Technical News 158

August 2014

Contents

Visual differences between Original and New Condition Fog Lights

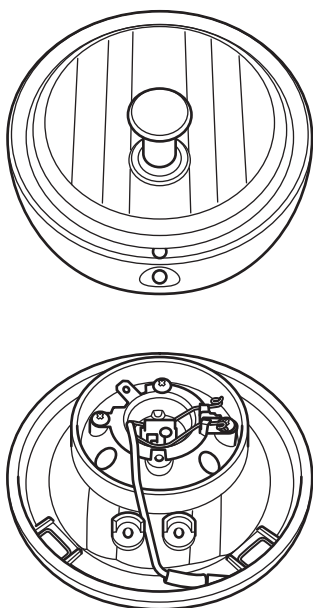
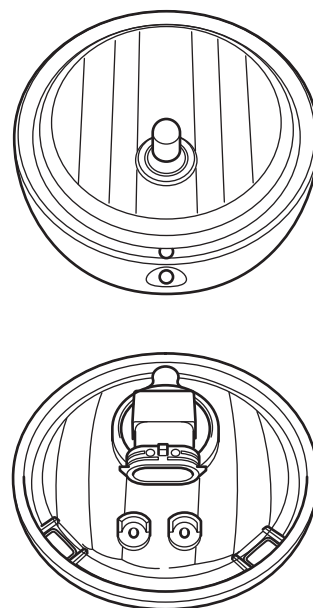
New fog lights have been introduced to the above model from VIN 660121 and are retrofittable. Parts no longer support the original condition.

The bulb wattage for the new condition fog lights has changed from 55 W to 35 W and the electrical connector is different.

- The replacement bulb is H8 12 V 35 W.

- If fitted with the original condition fog lights, the replacement bulb is H3 12 V 55 W.
- If fitted with the original condition fog lights and a fog light unit is to be replaced, both fog light units must be replaced. To facilitate this a spares kit (part number T2702727) is available.
- If fitted with the new condition fog lights, the replacement bulb is like for like H8 12 V 35 W.
- If fitted with the new condition fog lights, the fog lights can be replaced like for like. Refer to the EPC.

Description: Front Forks
Models affected: Daytona 675 up to VIN 381274, Daytona 675 from VIN 381275 to VIN 564947 and Street Triple R up to VIN 560476

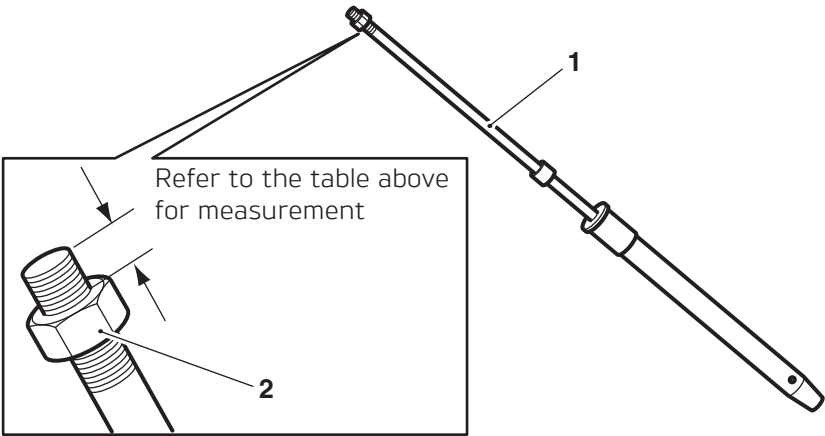
The measurement for the exposed thread above the damper rod lock nut described in the Service Manual for the above models is not correct.
When assembling the front forks of the above models, refer to the table below for the correct measurement of the damper lock nut position.

Model	VIN Range	Measurement
Daytona 675	Up to VIN 381274	12 mm
Daytona 675	From VIN 381275 to VIN 564947	11 mm
Street Triple R	Up to VIN 560476	11 mm

Description: Fall Detection Switch Retention Plate

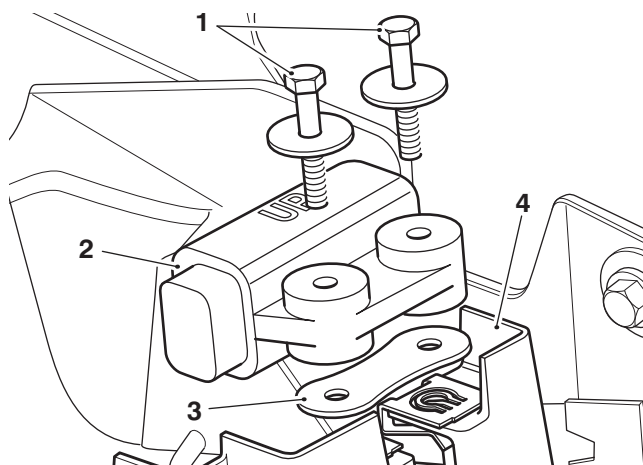
A retention plate located below the fall detection switch has been introduced to the above model from VIN 663379.

The removal and installation of the fall detection switch is as described in the Service Manual noting the addition of the retention plate.

Description: Upper Yoke Washers

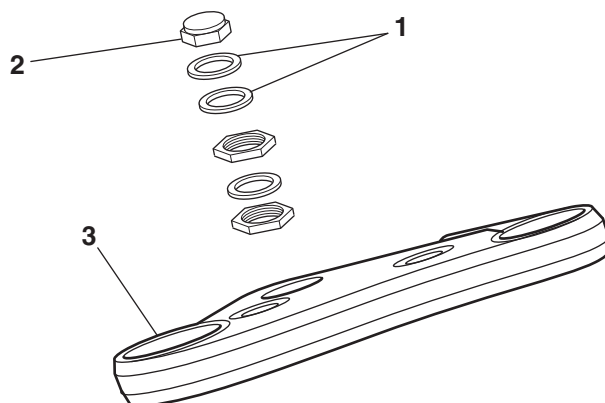
A second washer has been introduced to the above models from VIN 655530 and is located with the original washer between the upper yoke and its top nut. The torque figure for the top nut remains at **65 Nm**.

Description: ABS Brake Lines to ABS Modulator

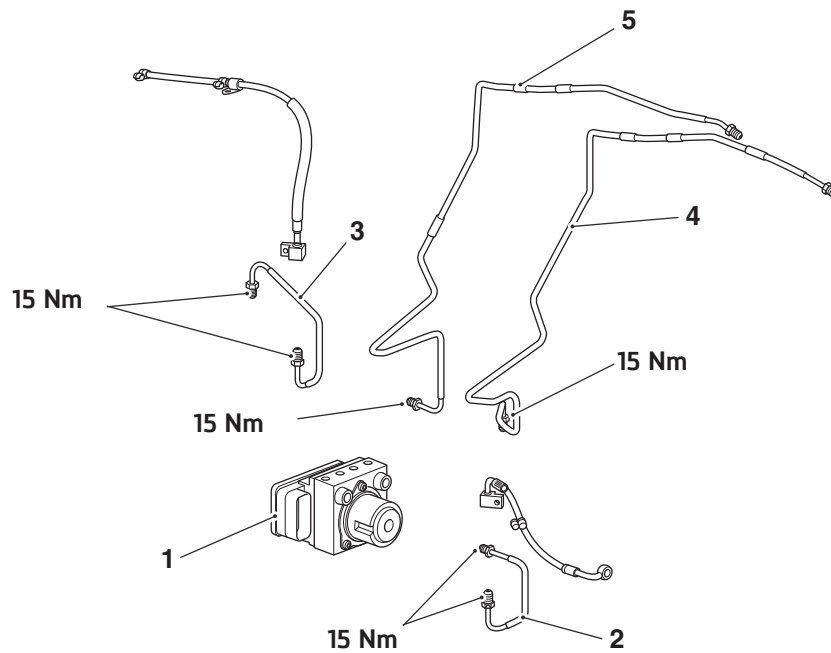
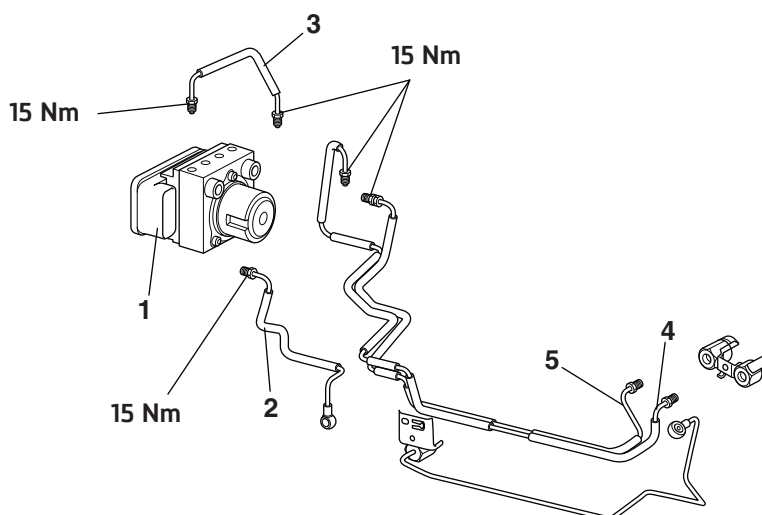
The torque figure for the 10 mm unions on ABS brake lines have changed to **15 Nm** on the above models.

- Models already in service need not be retightened unless the fixings have been loosened or removed.

Description: Centre Stand and Plastic Cover

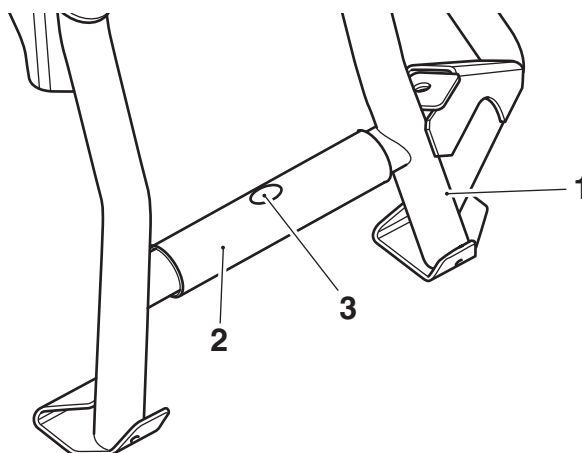
A plastic cover has been fitted to the centre stand on the above models from VIN 666617. The plastic cover is to prevent stone chip damage to the cross member of the centre stand.

If a new centre stand is required for models built prior to VIN 666617, a spares kit (part number 2081375) is available.

1. Remove the original centre stand from the motorcycle and discard the two fixings.
2. Fit the centre stand from the kit and tighten the new fixings to **50 Nm**.

3. Fit the plastic cover to the centre stand, as shown below, aligning the hole in the cover to the hole in the centre stand and fit the fir tree clip.

Description: Tyre Pressure Sensor, TPMS

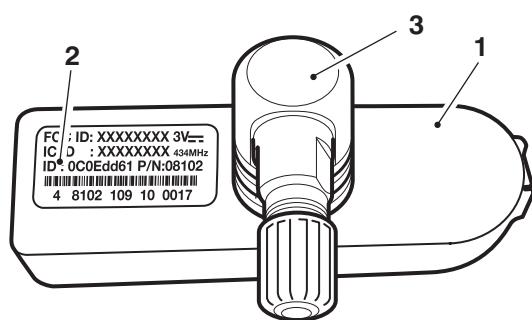
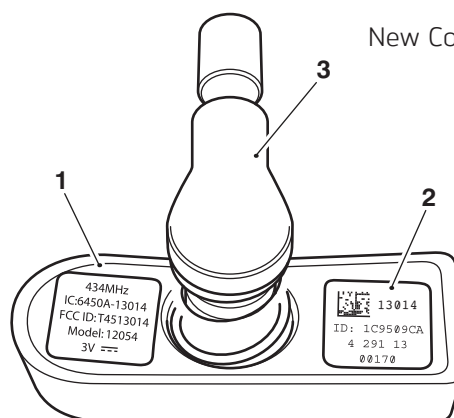
A new tyre pressure sensor has been introduced and is retrofittable. Parts will no longer support the original condition tyre pressure sensor.

The only visible difference between the original and new condition tyre pressure sensor is the tyre valve and the label with the sensor's ID number, as shown in the illustration below:

It is not necessary to replace both wheel tyre pressure sensors if replacing one of the original sensors with the new condition sensor.

Description: Oil Pump

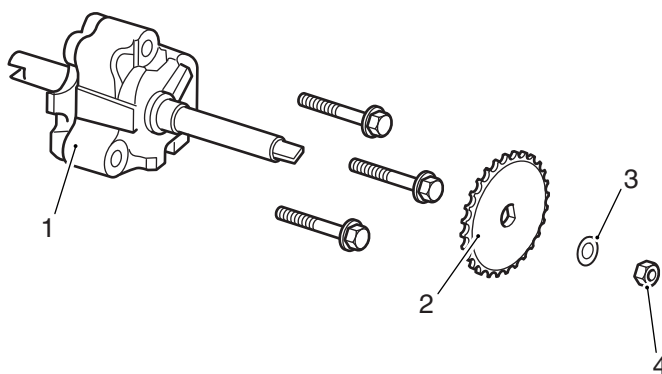
A washer has been introduced to the oil pump on the above models from engine number 655147. It is positioned between the oil pump sprocket and the lock nut. The addition of the washer enables the lock nut to have a greater thread engagement.

If the oil pump has been removed from engines built up to engine number 655146, Triumph recommend that a M10 washer (part number T3550239) is fitted between the oil pump sprocket and the lock nut on installation.

The torque figure for the lock nut remains at **30 Nm**.

Description: Clutch Cover

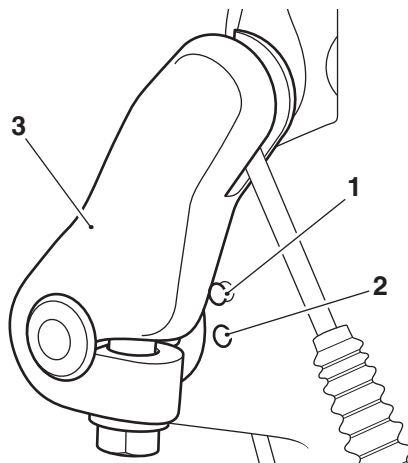
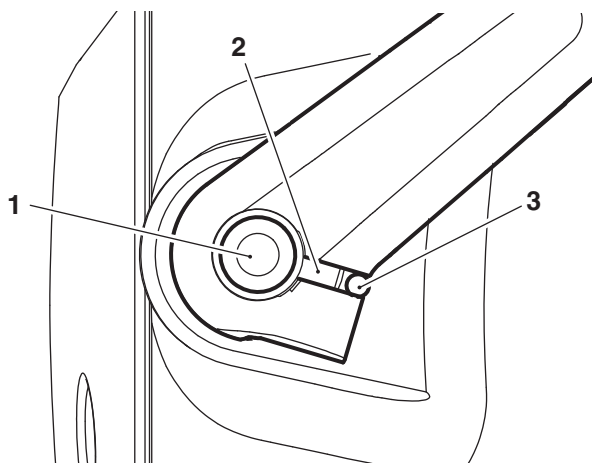
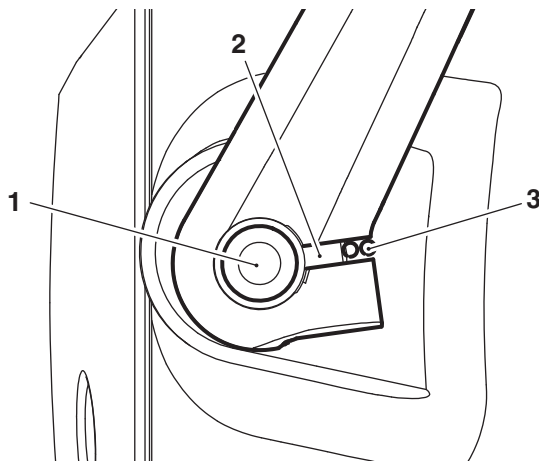
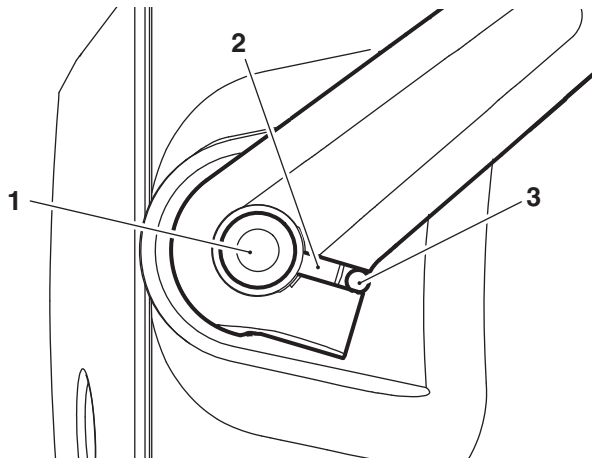
A new clutch cover has been introduced to the above models which has a single dot and two dot alignment marks for the clutch actuation lever. Due to the various finishes of the clutch covers, the new clutch cover has been introduced at various engine numbers with the first at engine number 669585.

With the clutch cable attached to the actuation lever, rotate the clutch shaft clockwise until the shaft makes contact with the clutch pressure plate bearing. Align the split to the single dot alignment mark and fit the actuation lever to the clutch shaft as described in the Service Manual.

With the clutch cable attached to the actuation lever, rotate the clutch shaft clockwise until the shaft makes contact with the clutch pressure plate bearing. Then align the split line in the clutch actuation lever to the two dot alignment marks on the clutch cover then fit the lever as described in the Service Manual.

1. Rotate the clutch shaft clockwise until the shaft makes contact with the clutch pressure plate bearing. Then align the split in the clutch actuation lever to the single dot mark on the clutch cover.

2. While holding the clutch shaft in position, rotate the actuation lever **two** splines anti-clockwise then fit to the shaft.

Description: Pannier Rear Mounting Bracket

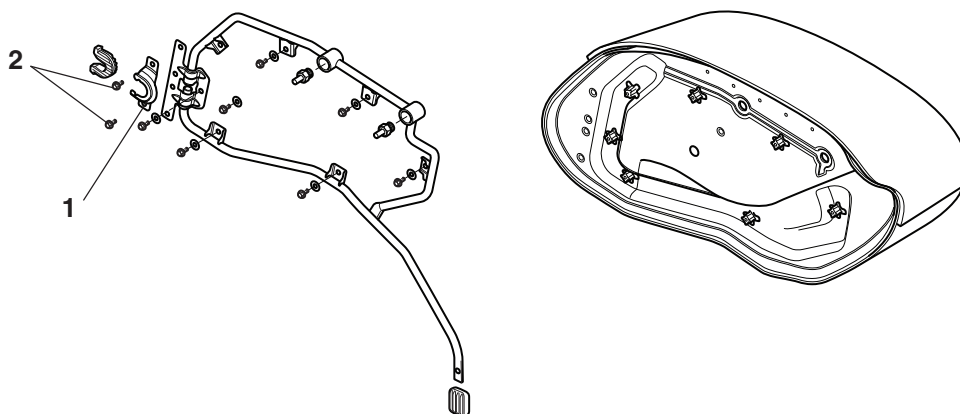
The torque figure for the rear mounting bracket fixings on the panniers has changed to **9 Nm** on the above models.

- Models already in service need not be retightened unless the fixings have been loosened or removed.

Description: Main Harness Conduit

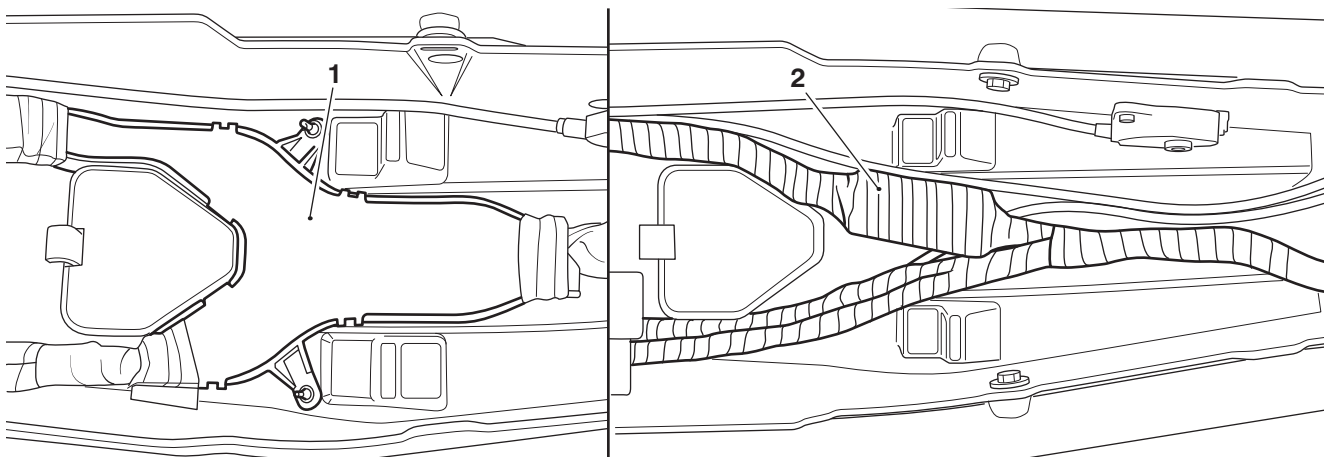
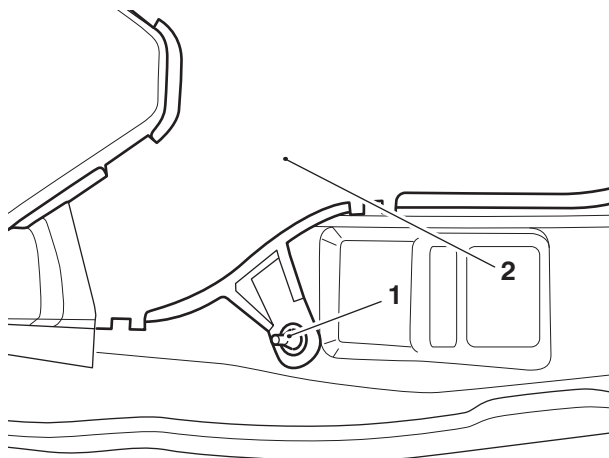
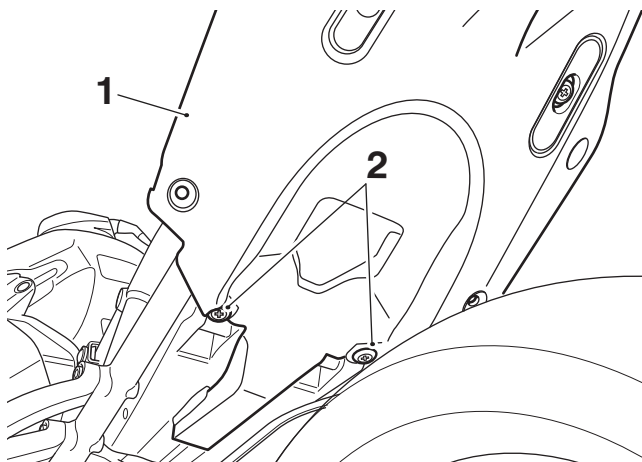
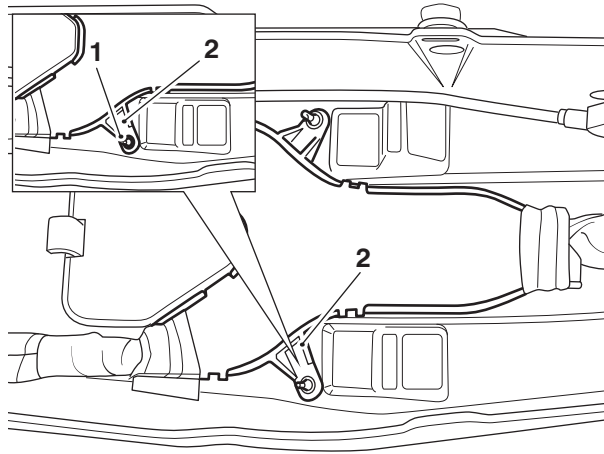
A new conduit has been introduced to the main harness on the above models from VIN 670284 and is retrofittable.

The new conduit is held in position by the two scrivets that secure the front of the rear panel to the battery tray.

When fitting the new condition harness, the following actions must also be carried out for the conduit:

1. Remove the scrivets securing the front of the rear panel to the battery tray.

2. With the conduit positioned in the battery tray as shown below, refit the two scrivenets ensuring they also secure the harness conduit.

Description: Detent Wheel and Pivot Plate

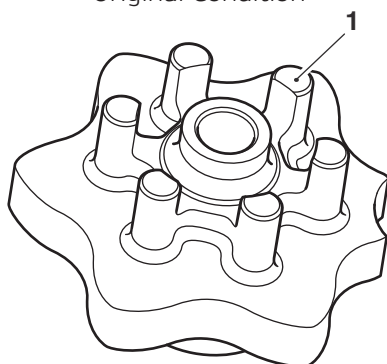
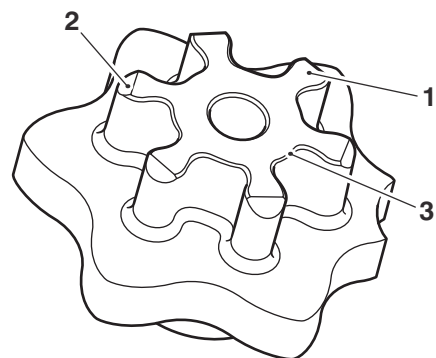
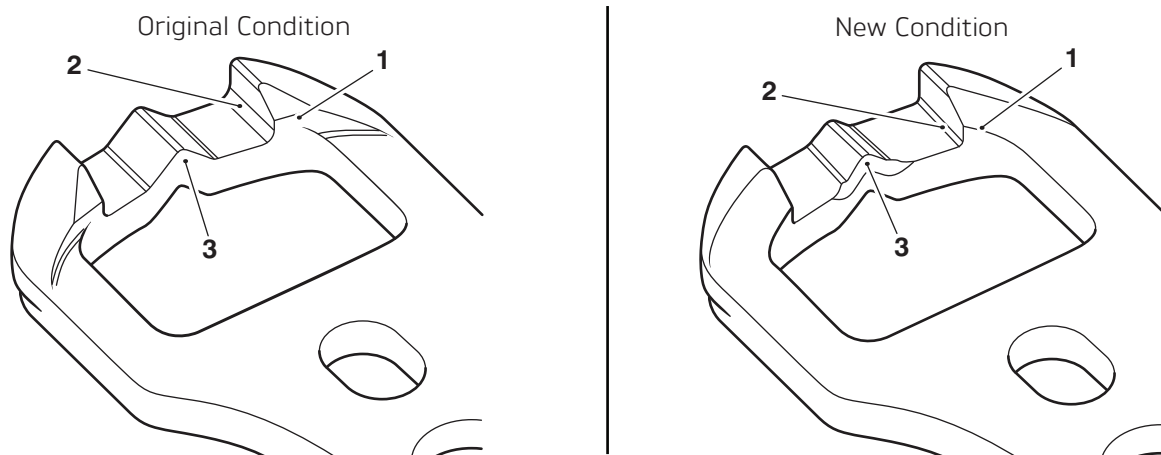
A new detent wheel and pivot plate for the gear selector mechanism has been introduced to the above models from engine number 662498.

- Profiled cut-outs to the pins
- Strengthening webs between the pins and the main body.

- The ramp of the driving claw
- The central claw is smaller
- The root radius of the driving claw is smaller.

- If replacing the pivot plate with a new condition part, the detent wheel must also be replaced with the new condition detent wheel. To facilitate this, a spares kit (part number T1194905) is available.
- If replacing the original condition detent wheel, the new condition detent wheel can be fitted without renewing the pivot plate.

For engines built from engine number 662498, the items can be replaced like for like, refer to the EPC.

Description: Oil Filter Adaptor

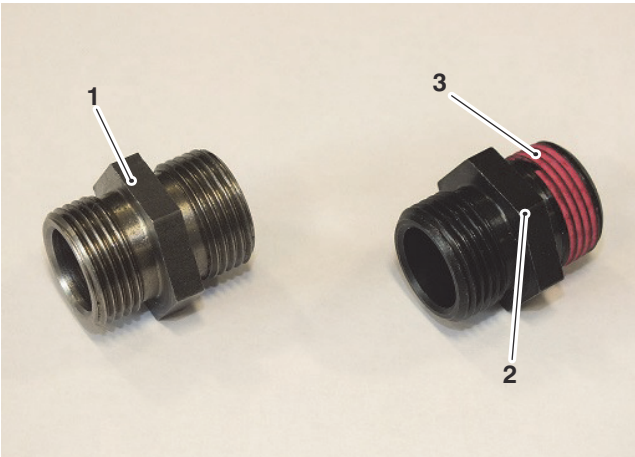
A new oil filter adaptor has been introduced to the above engines. The original adaptor, part number T1210523, requires ThreeBond 1305 to be added to the threads for the crankcase side and is torqued to **10 Nm**. The new adaptor, part number T1210438, is darker in colour and has the pink encapsulating compound on the threads for the crankcase side and is torqued to **16 Nm**.

For engines with the original oil filter adaptor, if removed from the crankcase side the threads must be cleaned and fresh ThreeBond 1305 applied to the threads for the crankcase side only and torqued to **10 Nm**. If a new oil filter adaptor is to be fitted, fit the new condition adaptor with the encapsulated compound. Fit the threads with the encapsulated compound to the crankcase side and tighten to **16 Nm**.

For engines with the new condition oil filter adaptor, if removed from the crankcase side it must be discarded and a new one fitted with the encapsulated threads to the crankcase side and torqued to **16 Nm**.
